Public Examination of Lewisham Town Centre Local Plan

London Borough of Lewisham response on the Inspector's Initial Questions 7 and 8 (Retail categorisation).

Planning Policy - 23rd November 2012

Fig. 3.1

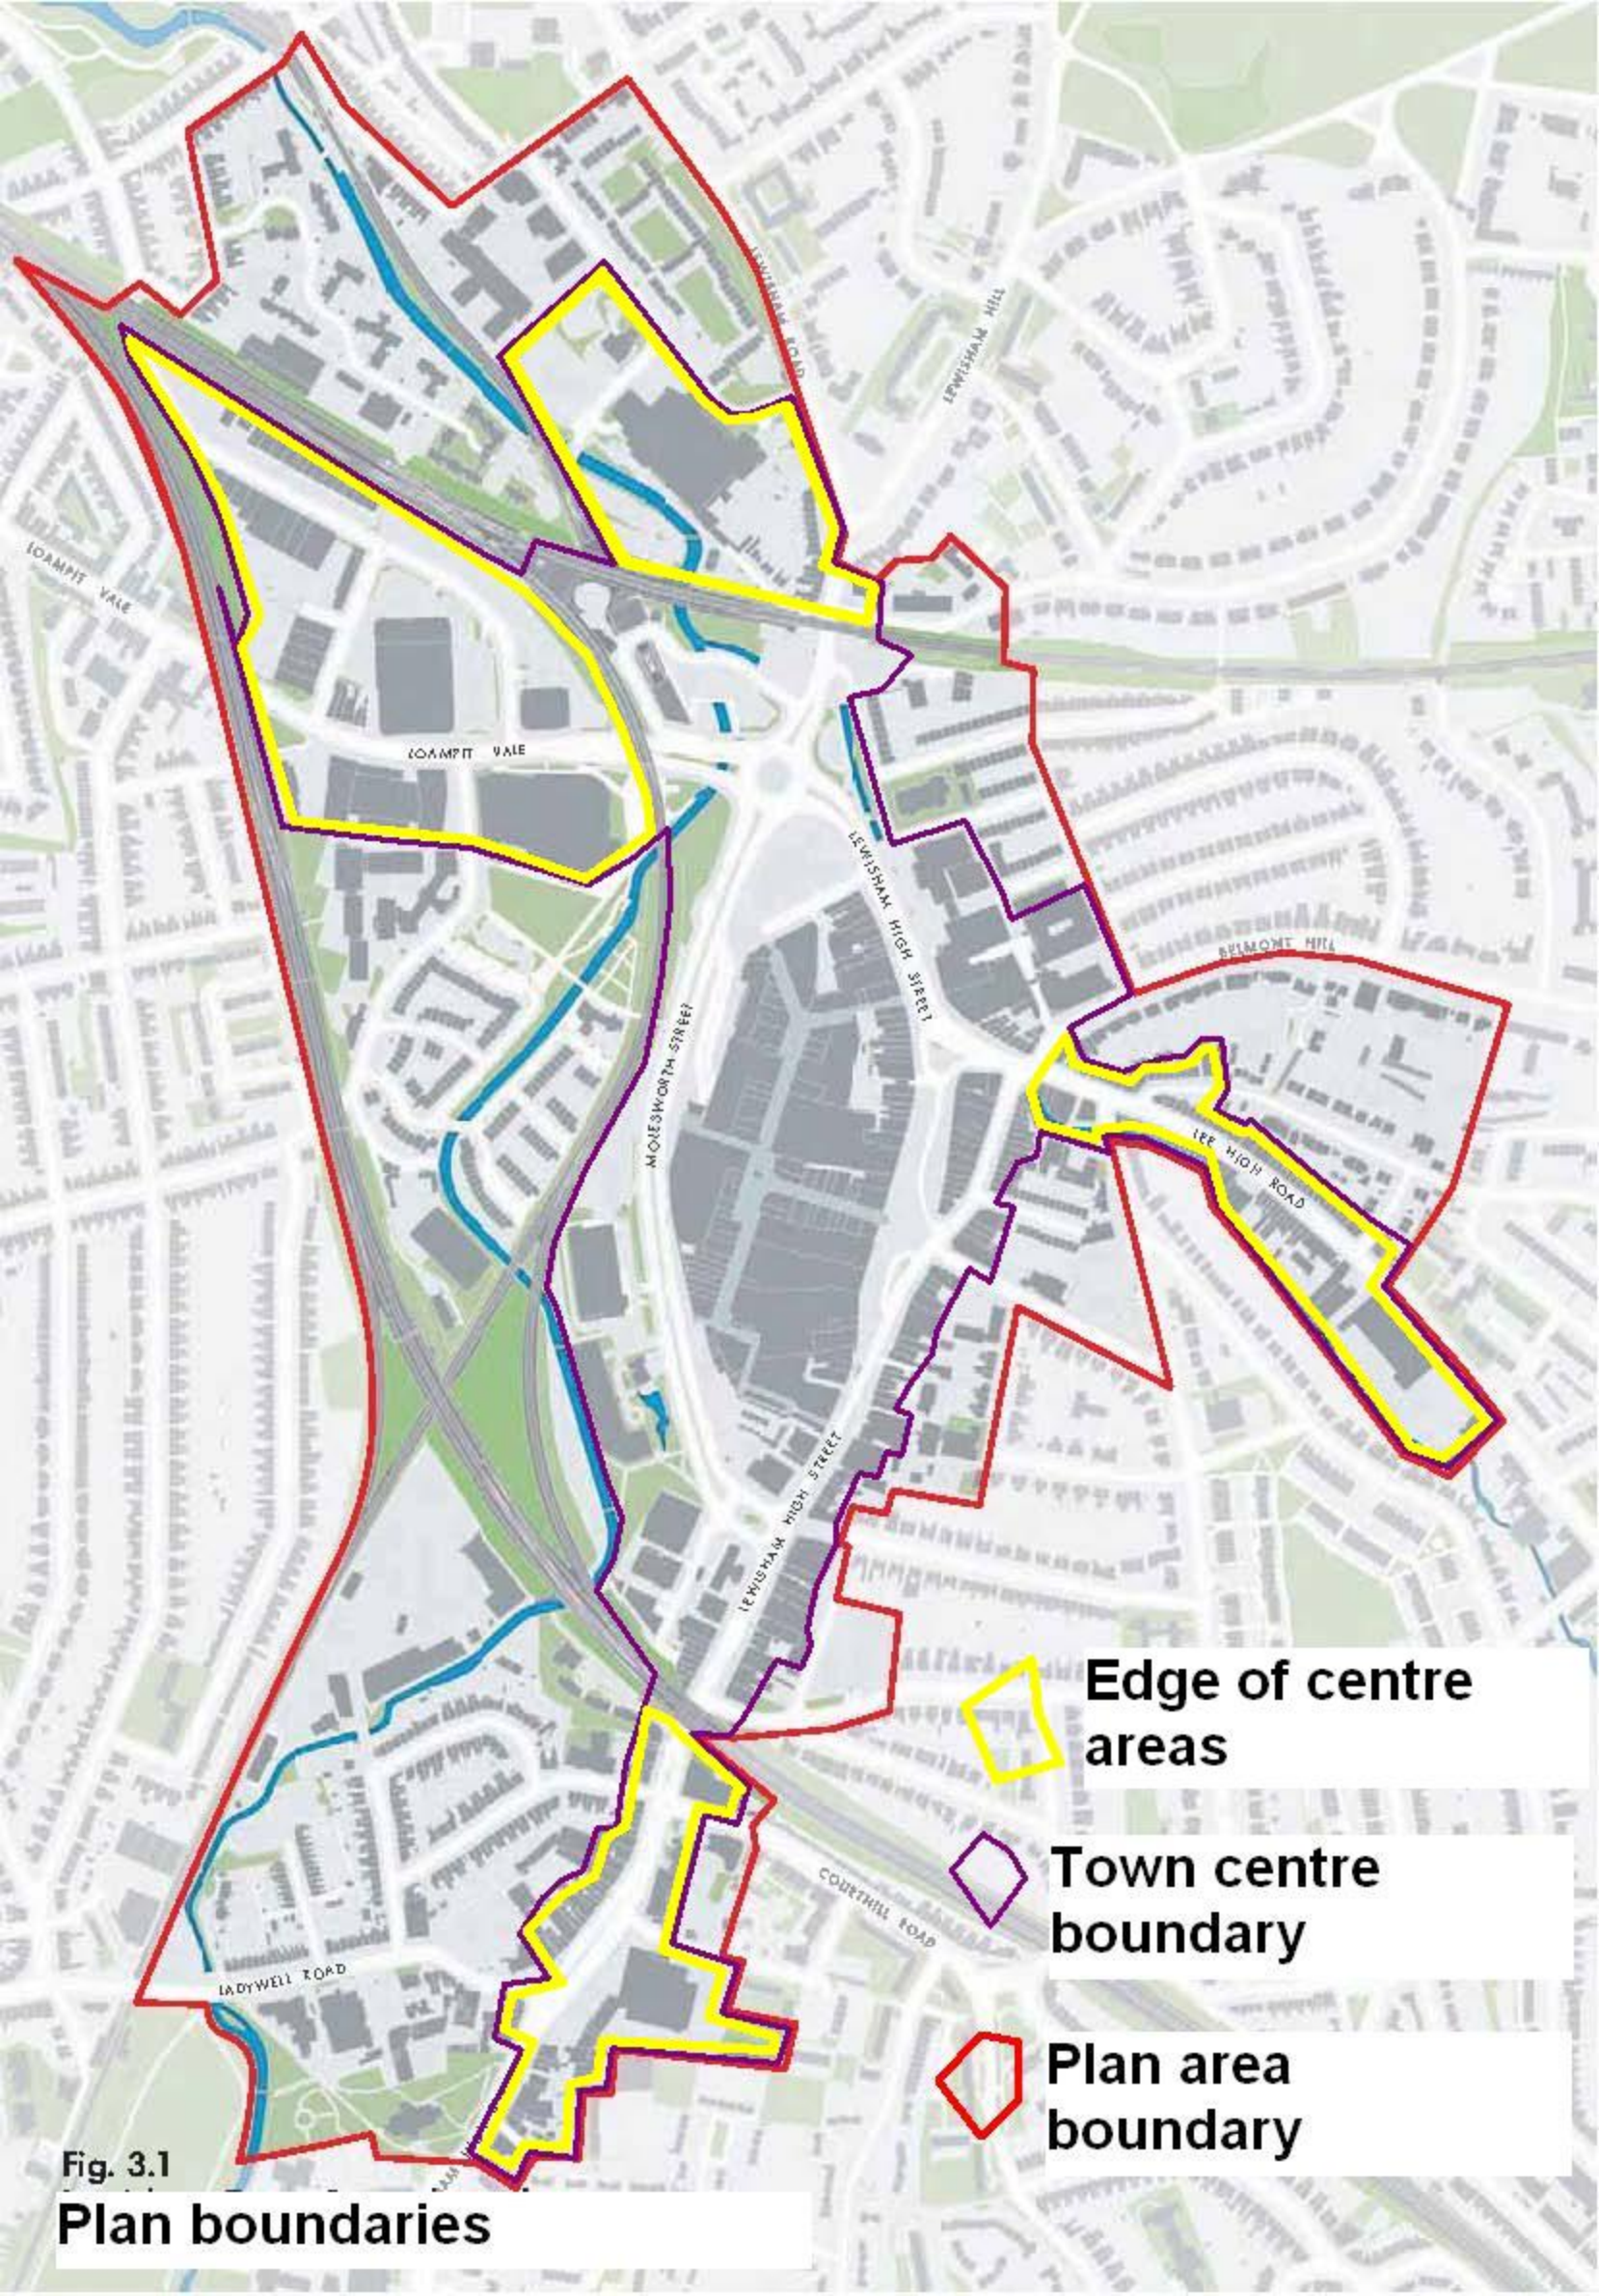
- 2.1 The Inspector suggests that the "town centre boundary" identified in Figure 3.1 of the LTCLP is in actual fact the area covered by the LTCLP. The Council agree with this assertion and would like to clarify that it has always been the intention of Figure 3.1 to show the plan area. The Council propose to amend the legend of Figure 3.1 to rename "Town centre boundary" to "Plan area boundary".

- 2.2 In order to provide further clarity, the Council also propose to add a "town centre boundary" to Figure 3.1. The Council consider that this is not a replacement for the previous incorrectly named "town centre boundary" described above, but is a new addition to the map to reflect the NPPF glossary definition of "town centre". A further proposed addition details those parts of the town centre that are considered as "edge of centre" in line with the definition included in the glossary of the NPPF.

- 2.4 As a result of the proposed changes, both Section 3.1 and Figure 3.1 should be renamed “Plan boundaries”. There are also amendments that will be required to the text in Section 3.1 to reflect the map changes. Proposed amendments to Figure 3.1 are demonstrated in Appendix 1 to this report (note: Appendix 1 is an indicative draft replacement map. The Council would seek a professionally produced map for insertion into the adopted plan). Proposed amendments to the text in Section 3.1 of the LTCLP are detailed in the box below. (Note: It is proposed to add the **bold and underlined text** and delete the ~~strikethrough text~~).

- 3.1 It is proposed to define the “town centre boundary” as detailed in the box above and the amended Figure 3.1 in Appendix 1 to this paper (note: Appendix 1 is an indicative draft replacement map. The Council would seek a professionally produced map for insertion into the adopted plan).

Fig. 5.1
Retail designations

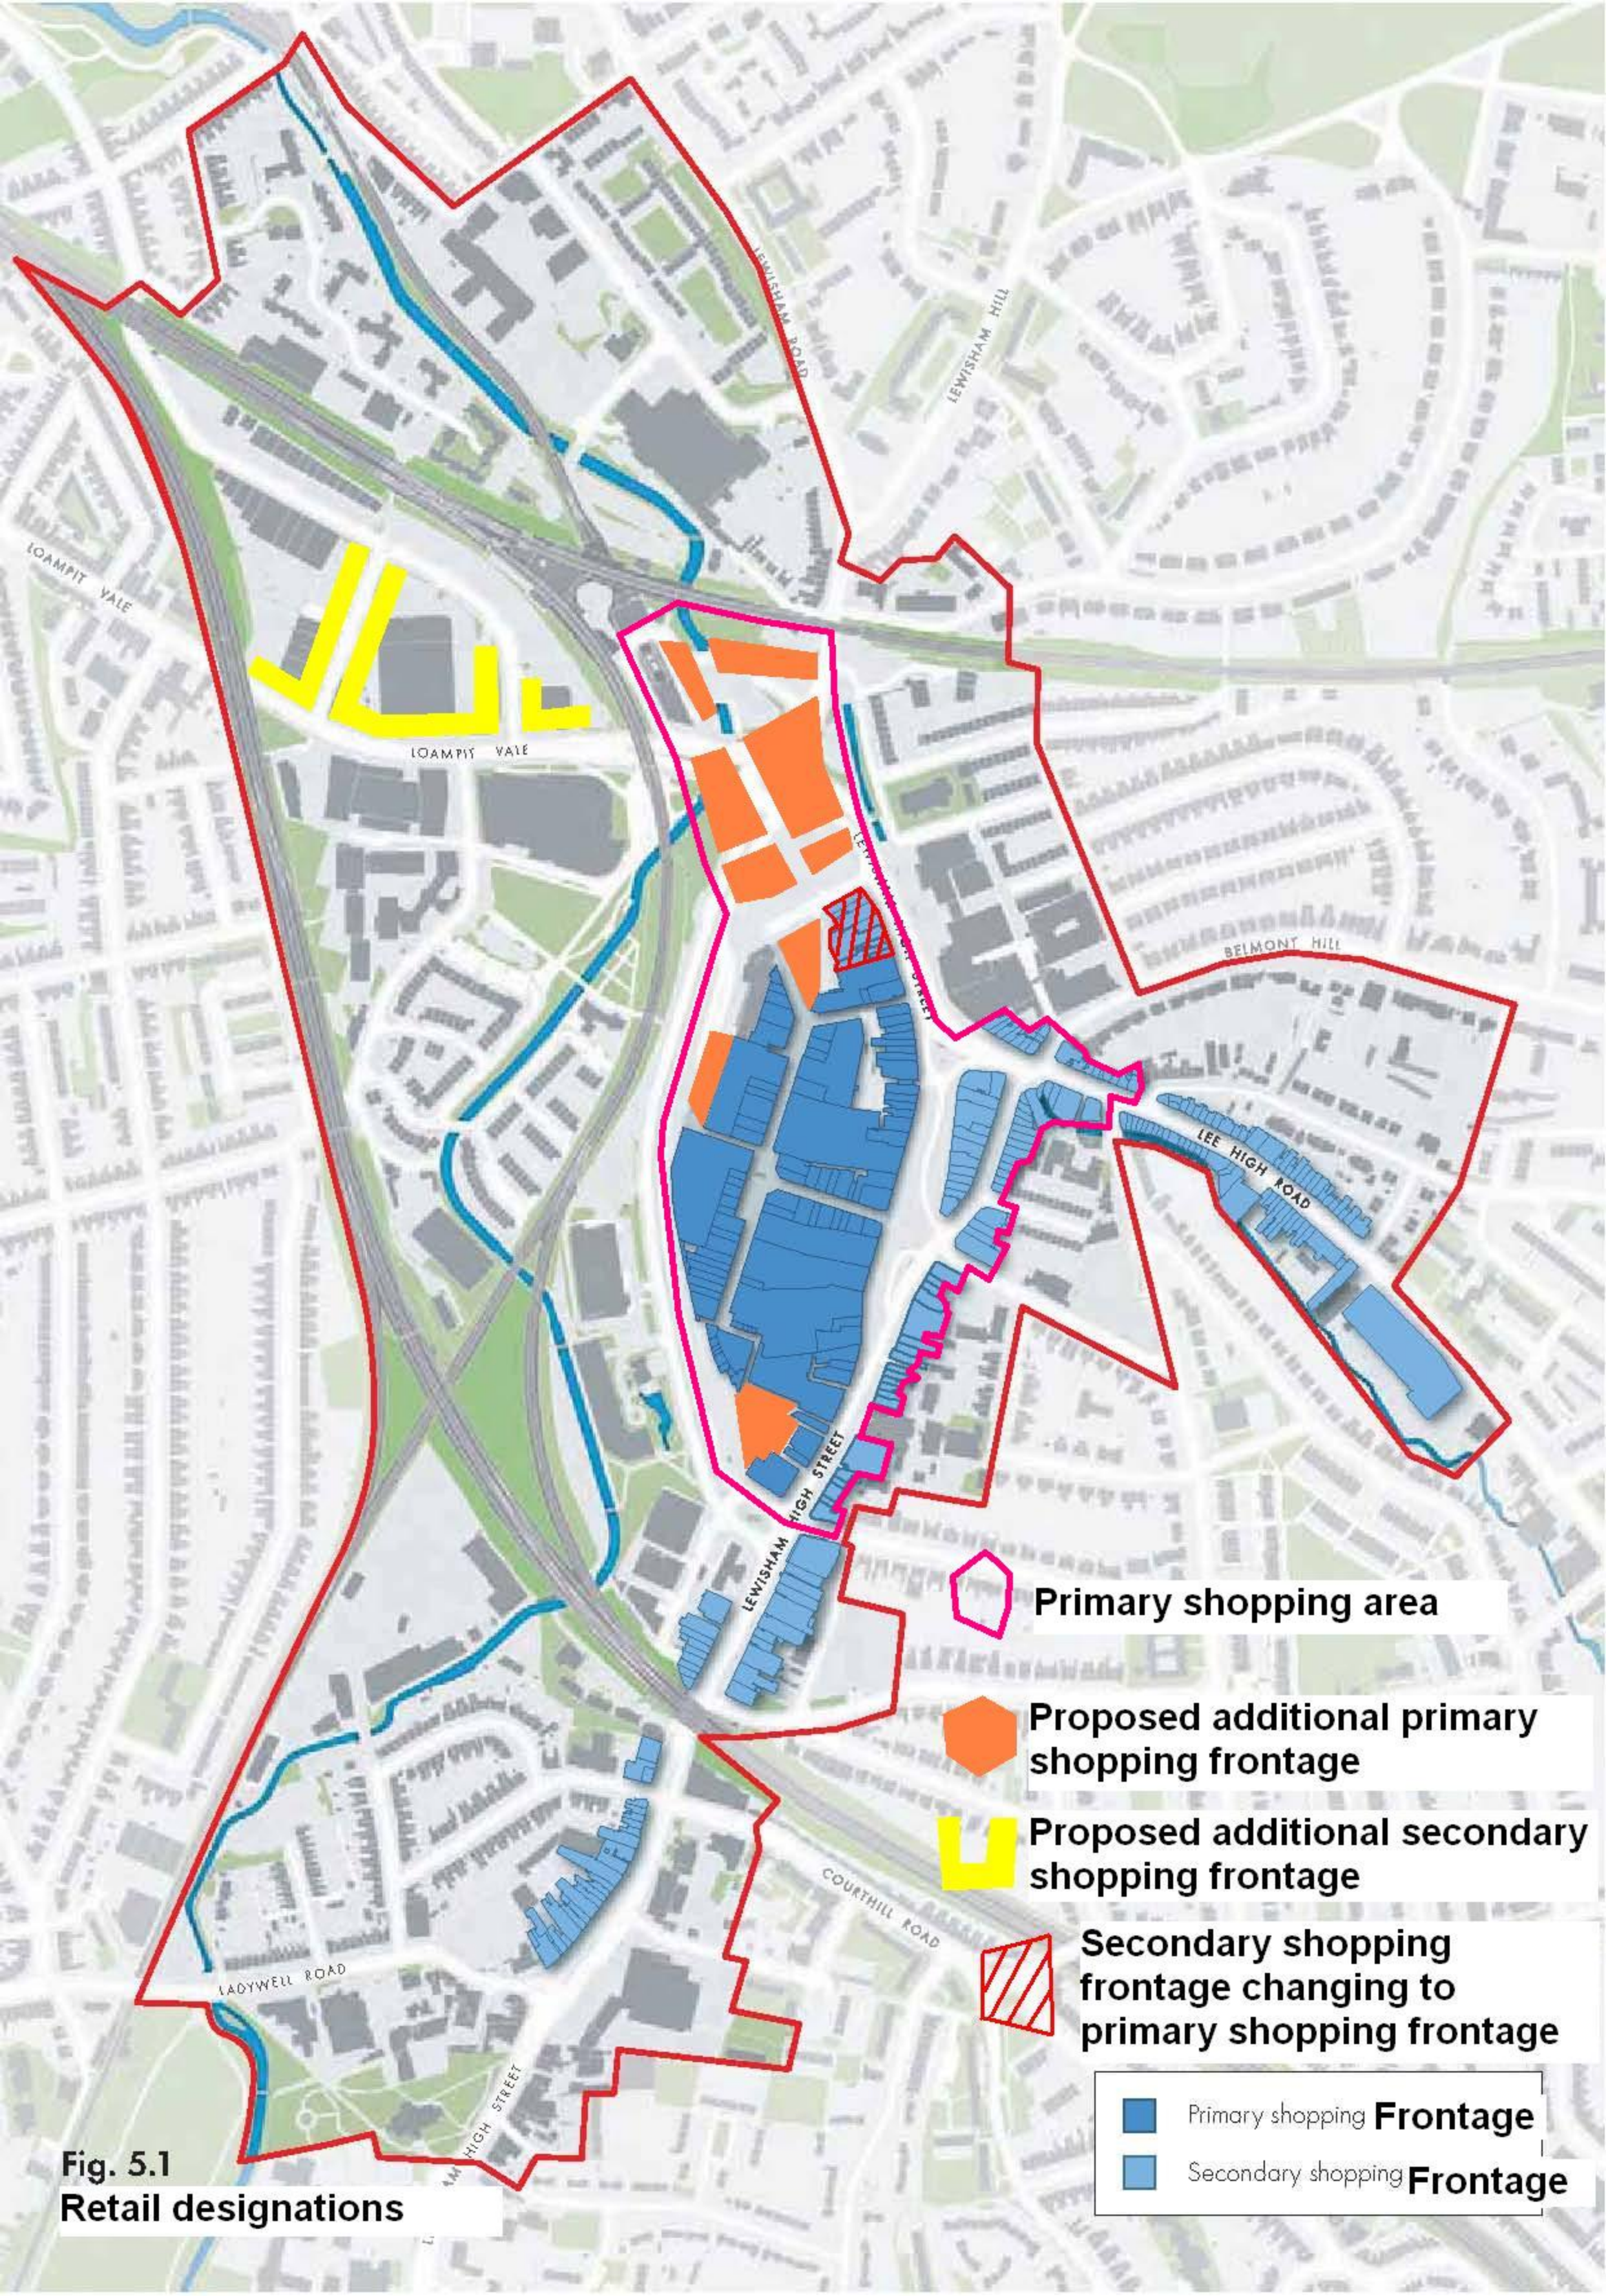
- 4.2 The proposed corrected terminology is to be implemented throughout the document, including in the legend of Figure 5.1 (See amended map in Appendix 2 to this paper) (note: Appendix 2 is an indicative draft replacement map. The Council would seek a professionally produced map for insertion into the adopted plan).

- 4.4 The Council confirm that the new retail/leisure floorspace detailed in the LTCLP in the Central Town Centre Area and on the Lewisham Gateway site is intended to extend the ‘primary shopping frontage’. It is therefore proposed to show on Figure 5.1 the anticipated retail frontage in the area as ‘proposed additional primary shopping frontage’. Subsequently, for clarity, the Council believe it is appropriate to show part of Loampit Vale as ‘proposed additional secondary shopping frontage’. There is also a requirement to show a small section of shops in the town centre that are currently secondary shopping frontage as ‘proposed to change to primary shopping frontage after the completion of the Lewisham Gateway scheme’.

- 4.5 As explained in this paper, the submitted LTCLP has not up until this point designated or referred to a ‘primary shopping area’. However, the Council acknowledge that the NPPF definitions for ‘town centre’ and ‘edge of centre’ which are referred to in the LTCLP use ‘primary shopping area’ in their definitions. Therefore, for clarity, the Council propose to show the ‘primary shopping area’ on Figure 5.1 (See amended map in Appendix 2 to this paper) (note: Appendix 2 is an indicative draft replacement map. The Council would seek a professionally produced map for insertion into the adopted plan).

- 4.6 Figure 5.1 is titled ‘Retail areas’. The Council propose that for clarity this is renamed as ‘Retail designations’ (See amended map in Appendix 2 to this paper) (note: Appendix 2
